RYZ014A

LTE Cat-M1 Cellular Pmod™ Expansion Board
for RYZ014A
Errata

Renesas LTE Cat-M1 Cellular IoT Modules

Figure 1. RTS0 Pull-up Resistor R1

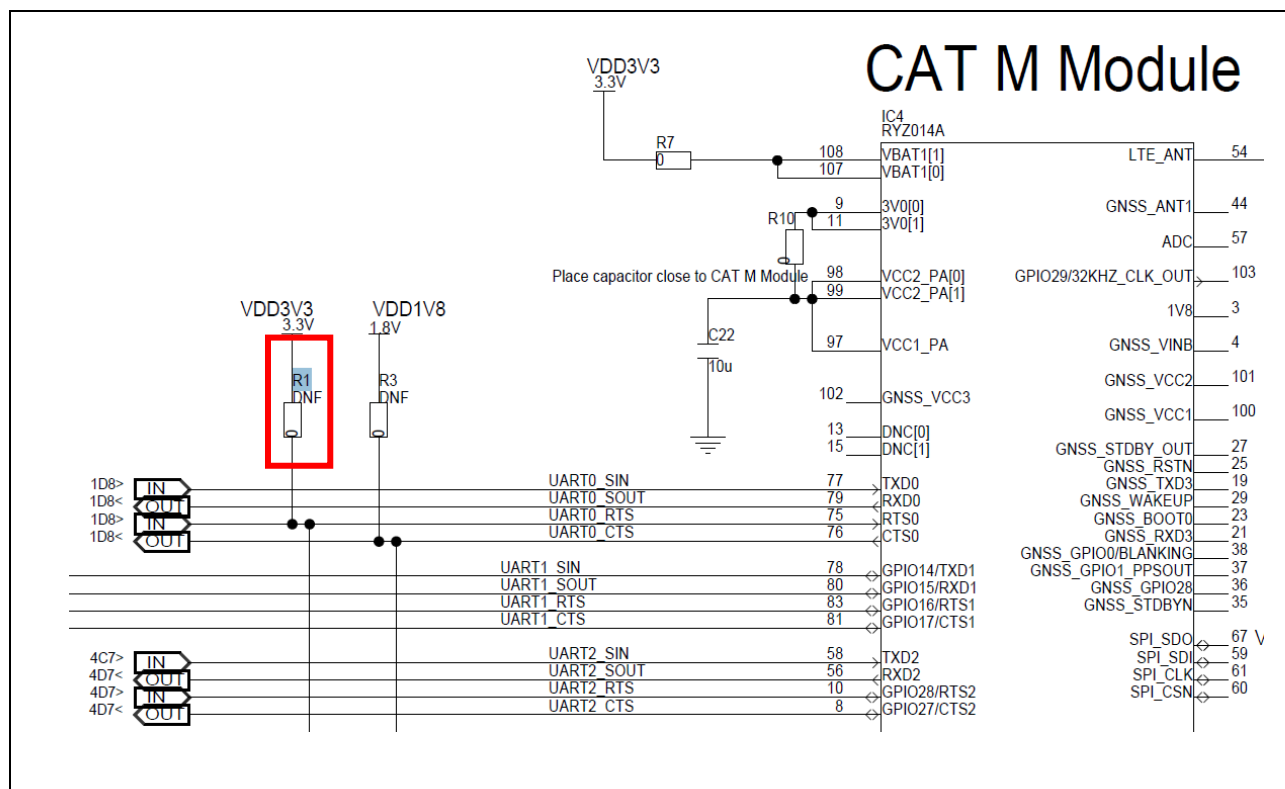
The RTS0 signal (pin 75) of the RYZ014A module should be pulled up to VDD1V8. On the schematic and board the 0R pull-up resistor R1 (DNF) is connected to VDD3V3.

In your own design implementation, ensure that the RTS0 signal is pulled up to 1.8 V if needed. Refer to the *RYZ014A Module Hardware Manual* and *RYZ014A Module Integration Guide* for more details – see resource links in section 3.

Figure 2. Module Power Enable POWER_EN

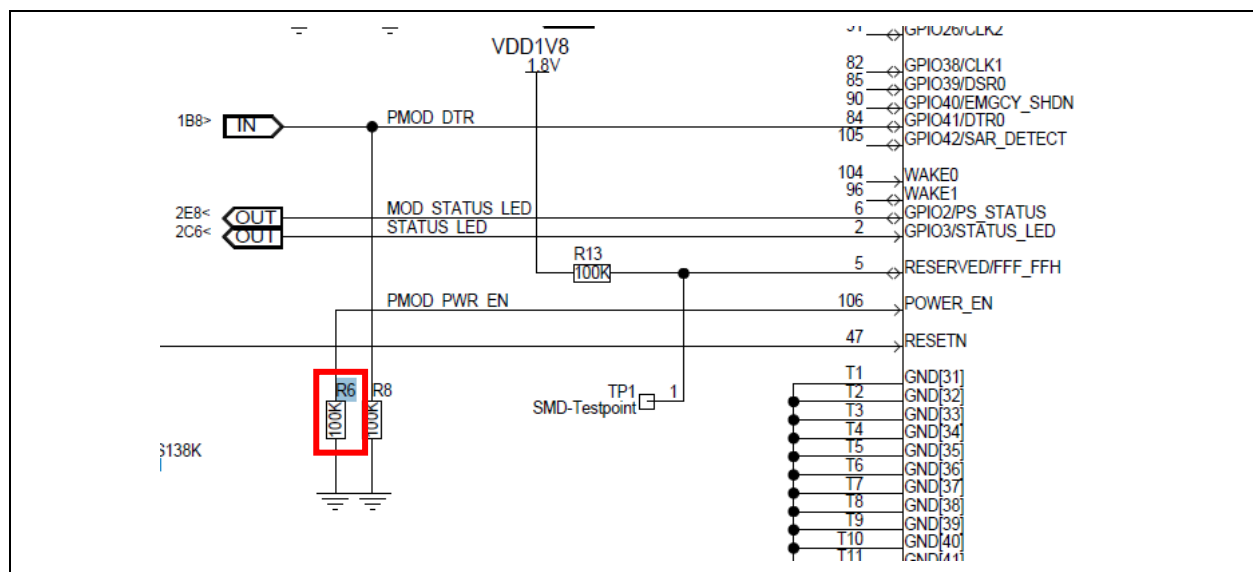
The module POWER_EN signal (pin 106) should be pulled down to GND via a 470K resistor. On the schematic and board a 100K pull-down resistor R6 is used.

In your own design implementation, ensure that this signal is pulled-down via a 470K resistor. Refer to the *RYZ014A Module Hardware Manual* and *RYZ014A Module Integration Guide* for more details – see resource links in section 3.

Figure 3. Reserved Pin GPIO23

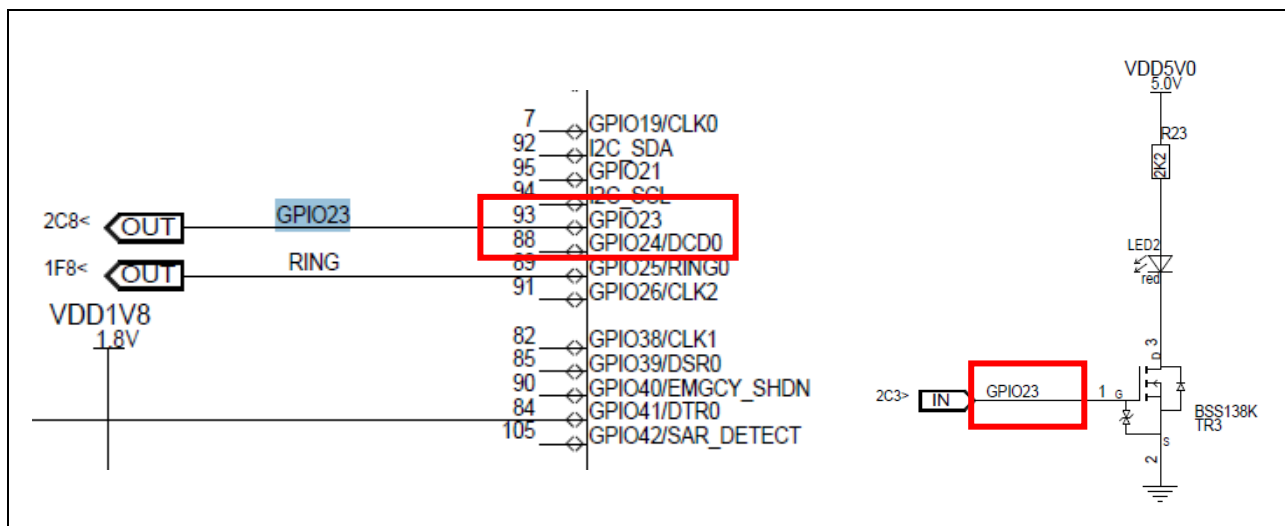
GPIO23 (pin 88) and GPIO24 (pin 93) are reserved pins and should not be used. On the board, GPIO24 (pin 93) is used to drive TR3.

On the schematic, GPIO23 is incorrectly identified as pin 93 and GPIO24 is incorrectly identified as pin 88.

In your own design implementation ensure that GPIO23 and GPIO24 are not connected. Refer to the module hardware manual for more details.
